**GPU Nuclear Corporation**

Subject: Oyster Creek Nuclear Generating Station  
Docket No. 50-219  
Spent Fuel Pool Expansion - Request for  
Additional Information

Enclosed please find the additional information requested by your letter of April 24, 1984.

INSTALLATION OF LIFTING RIG ONTO  
A MODULE POSITIONED IN THE POOL

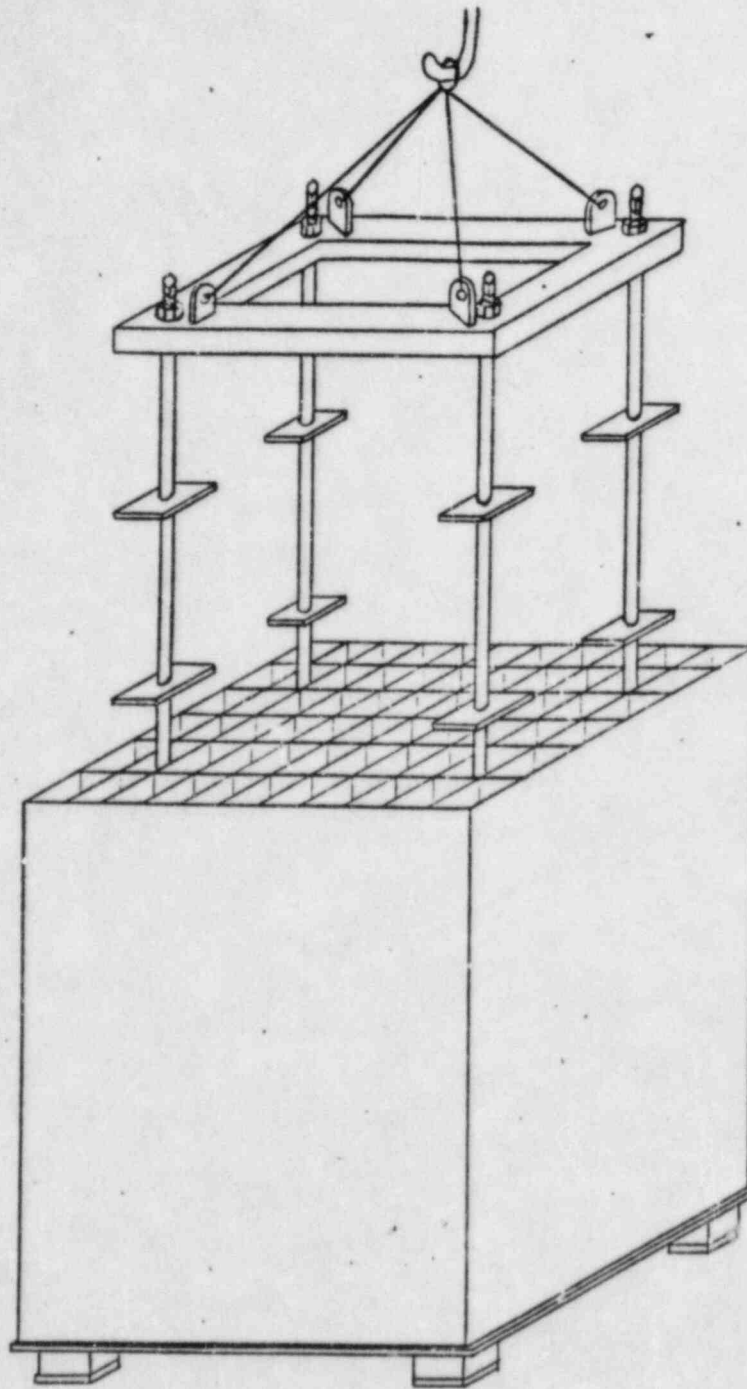
With the aid of drawings, describe and discuss the special lifting devices interposed between the new and old storage racks and the crane hook. Demonstrate that these devices meet the intent of NUREG-0512, Section 5.1.1(4) and (5).

The lifting device used for the new poison fuel racks is shown on the attached Figure 1. The qualifications for this equipment are noted in the response to Question No. 12.

The lifting equipment for the presently installed fuel racks and bases have not been designed yet. However, they will be qualified in accordance with the response to Question No. 12.

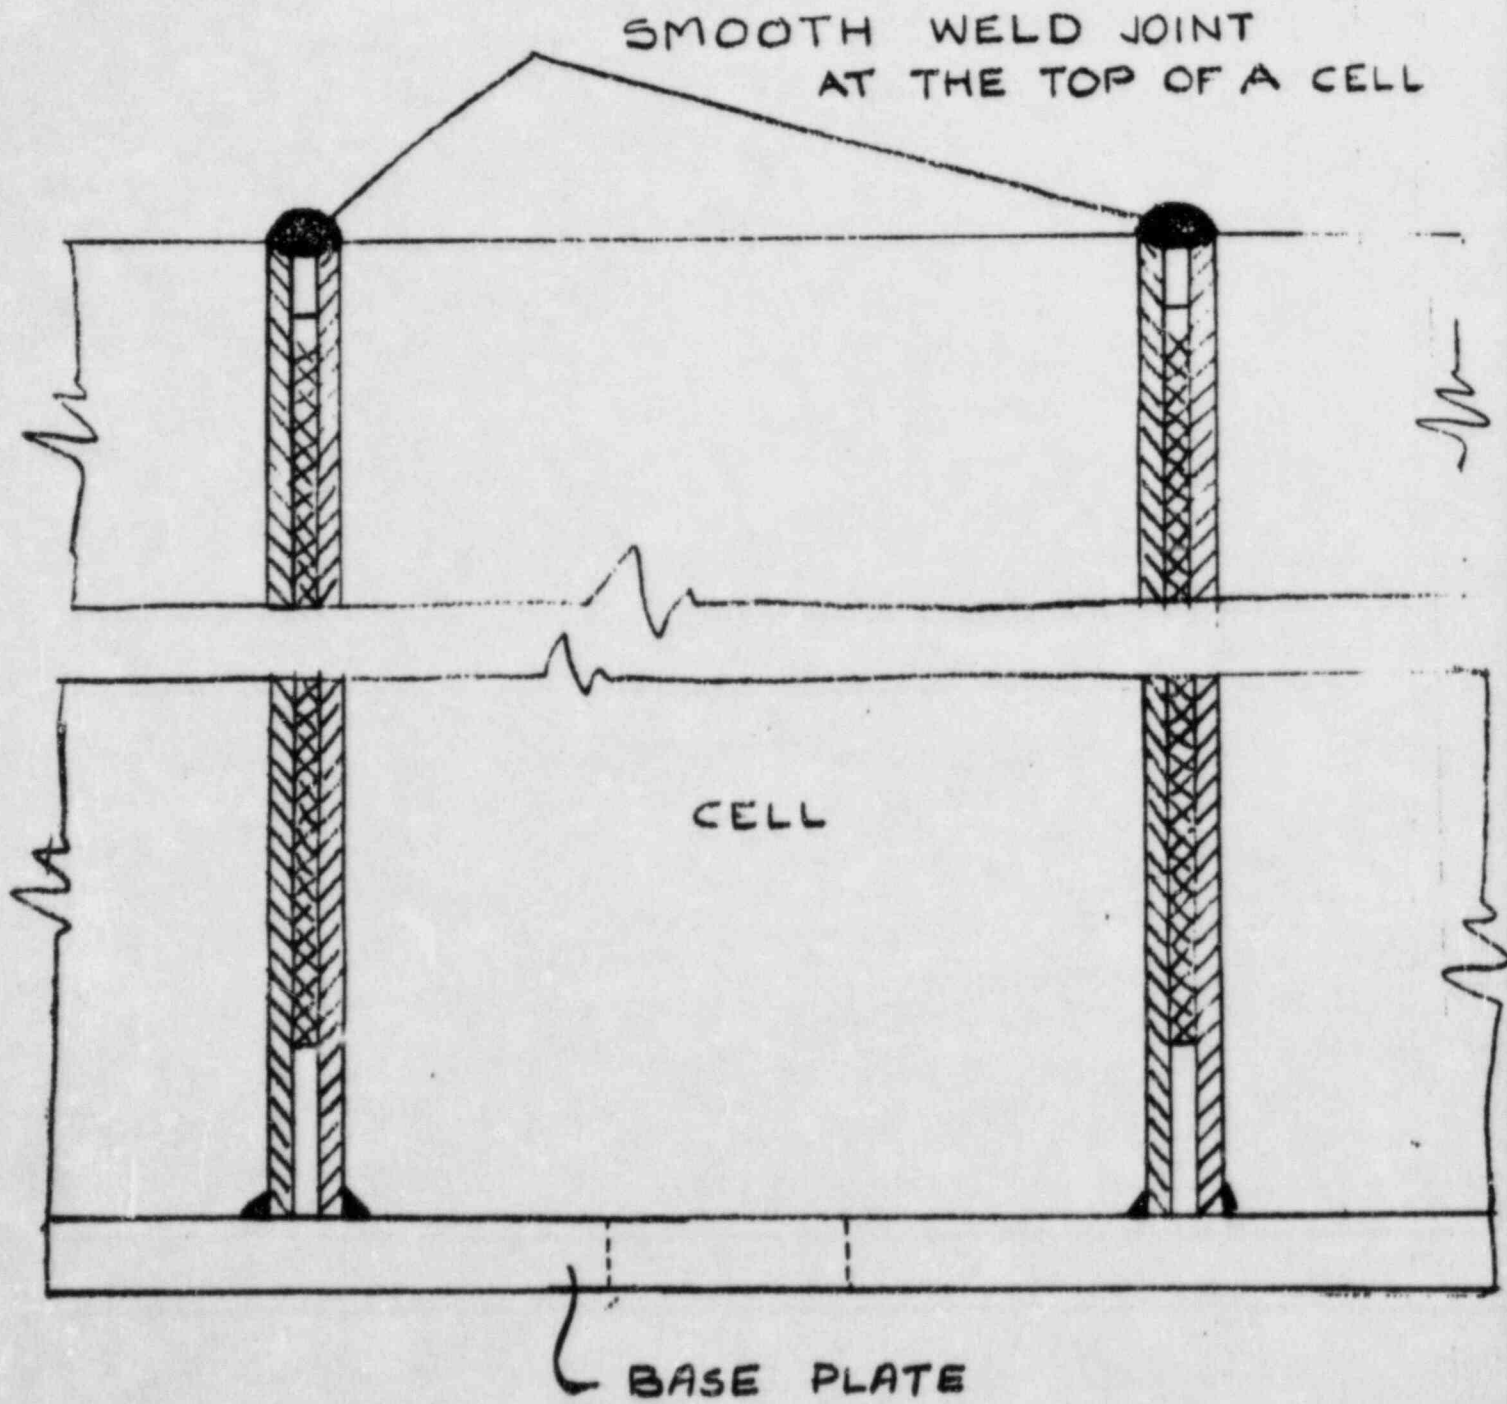
Provide a discussion which demonstrates that a fuel assembly can be safely inserted and withdrawn from the new storage cells that do not have chamfered guides to help align the fuel assembly with the storage cell.

The top of the storage location has a smooth edge cross section as shown in the attached sketch. This geometry provides a smooth insertion contour.
